ADDENDUM NO. 1 DATED 6/23/2016 ADDENDUM NO. _____ DATED _____
ADDENDUM NO. _____ DATED _____ ADDENDUM NO. _____ DATED _____

Number	Description
1	Revised Table of Contents; Delete NTB No. 1322; Revised NTB Nos. 5545, 6111, & 6119; Add NTB Nos. 6522, & 6523; Add SP 907-630-13; Delete SP 907-630-15, & 907-721-4; Revised Bid Items; Revised or Added Plan Sheet Nos. 2, 6, 8-9, 18-20, 22, 24-26, 37, 40, 42, 44, 50, 195, 197, 199, 205, 1001-1015, 3022-3024, 9045-9050 for Projects 102556306 & 307; Revised or Added Plan Sheet Nos. 2, & 11 for Project 102556318; Amendment EBS Download Required.

STP-0029-02(018) / 102556306000, STP-0029-02(018) / 102556307000 & STP-0029-03(015) / 102556318000
Desoto & Marshall County(ies)

PROJECT: STP-0029-02(018) / 102556306 - Desoto
STP-0029-02(018) / 102556307 - Marshall
STP-0029-03(015) / 102556318 - Marshall

EQ-13

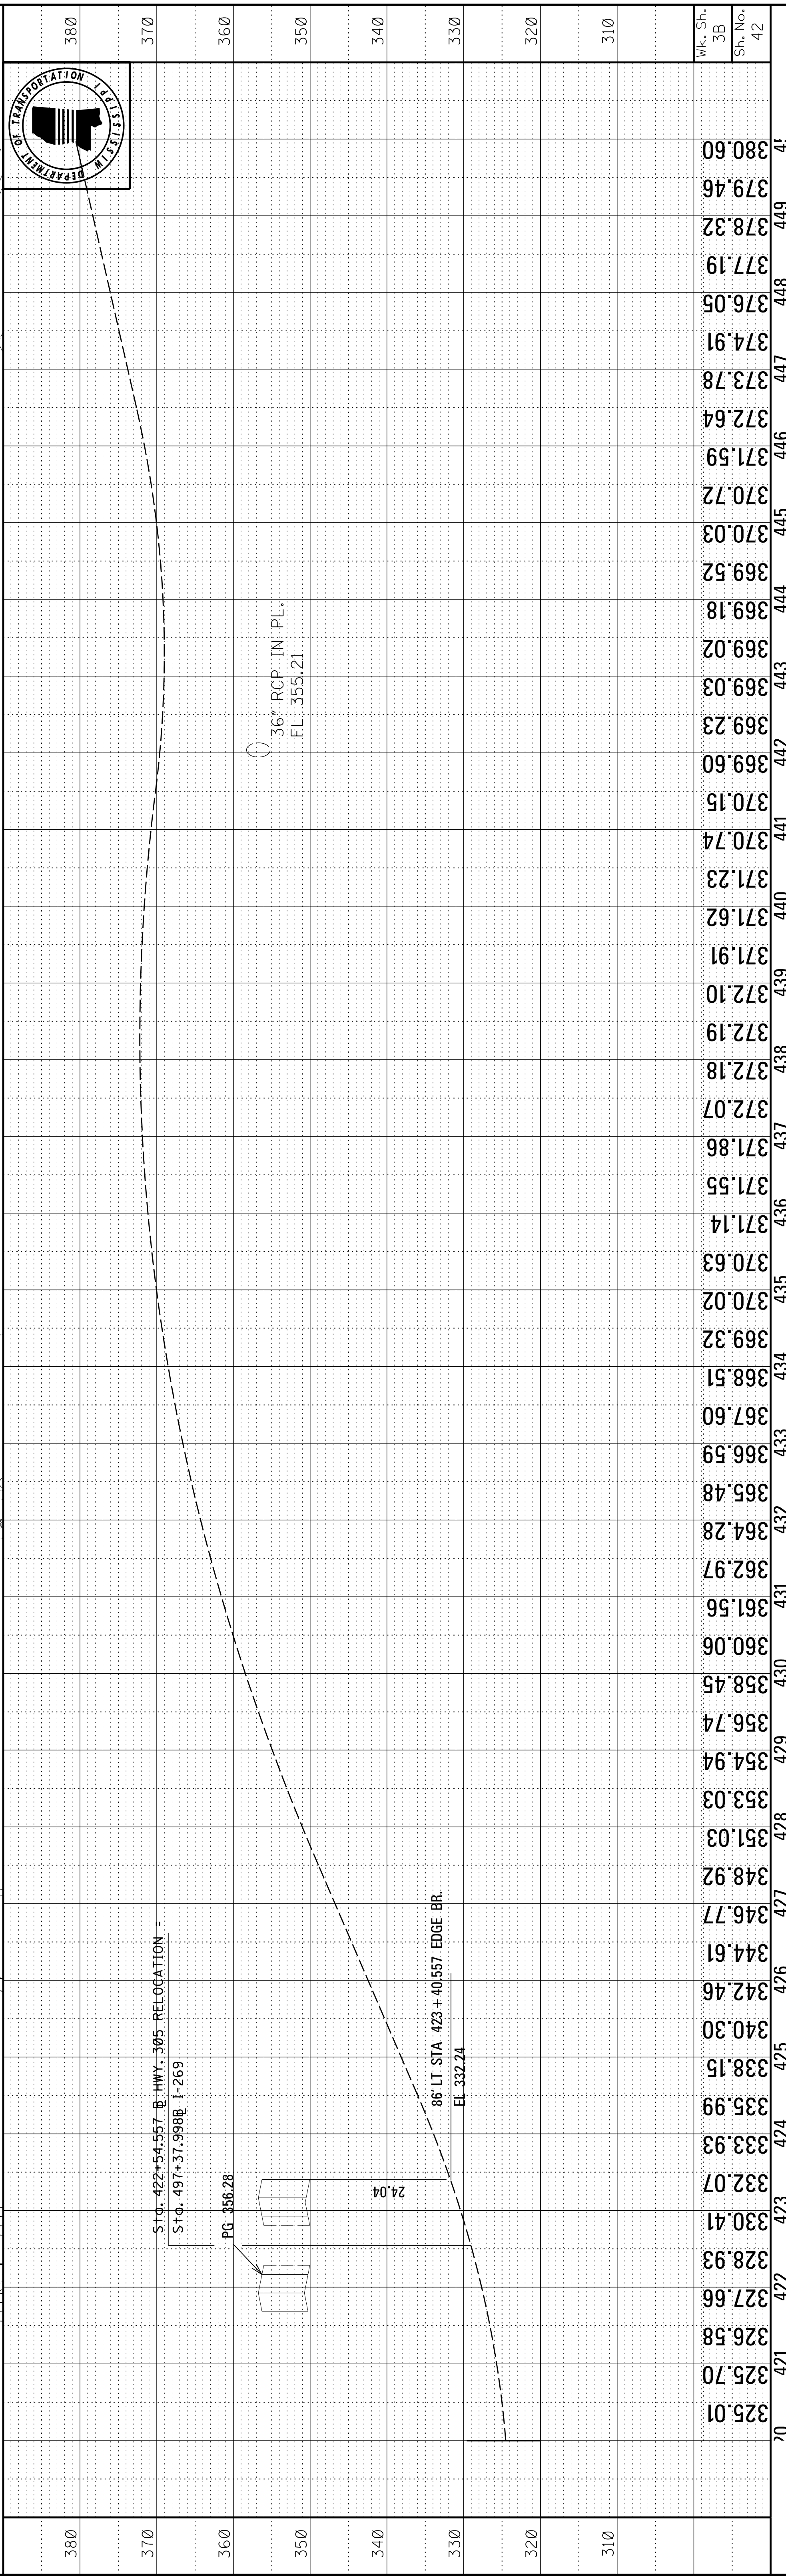
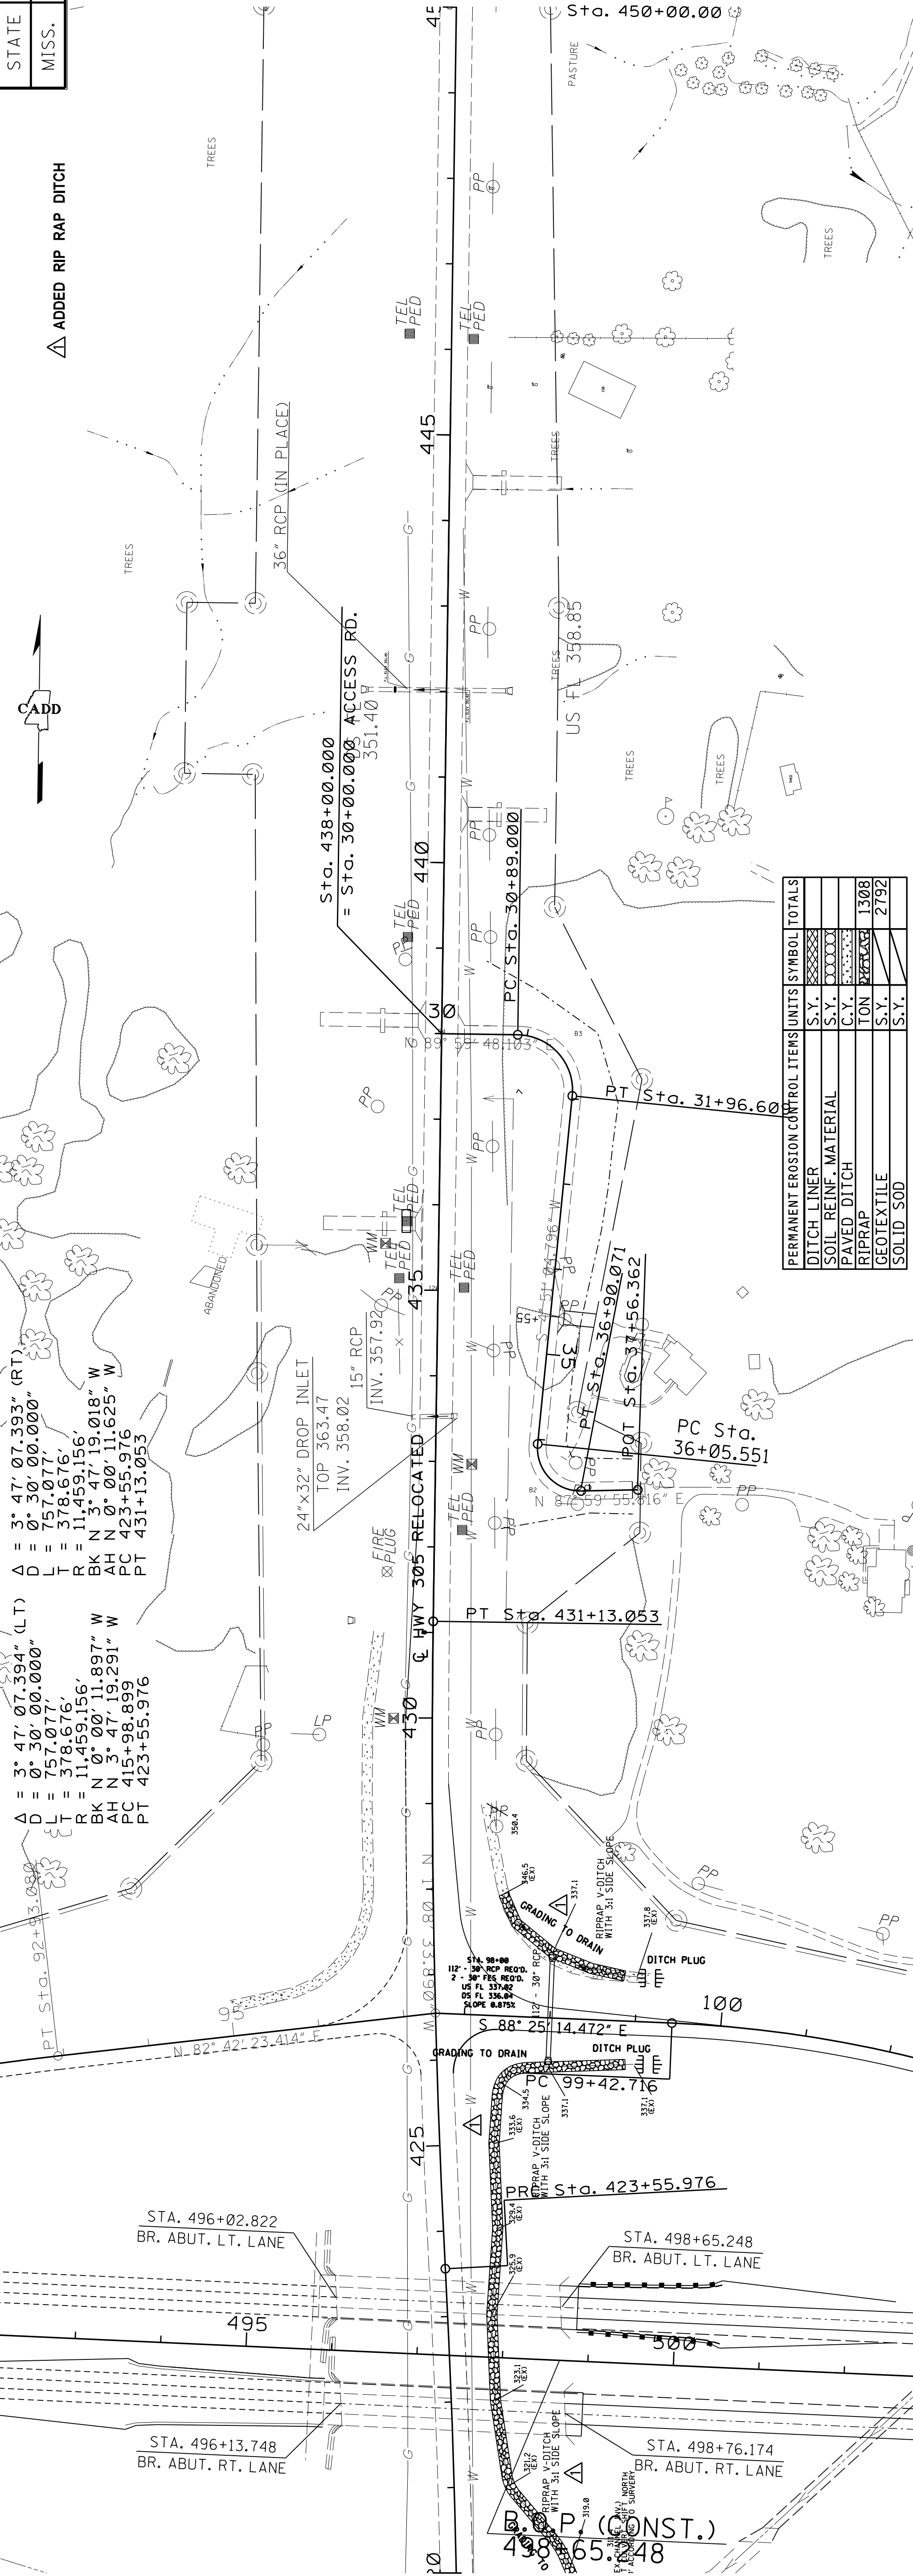
ADDED RIP RAP DITCH

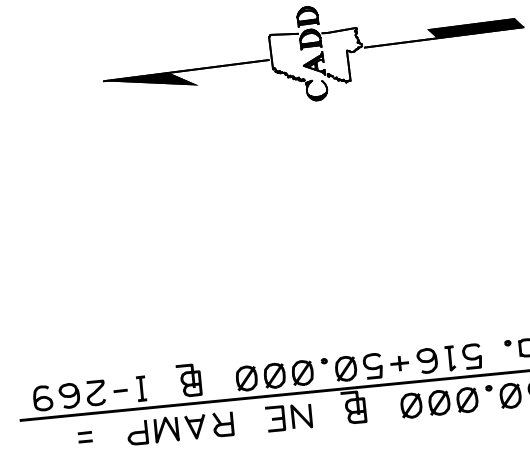
① ADDED PIPE, BOX
ACCESS RD.
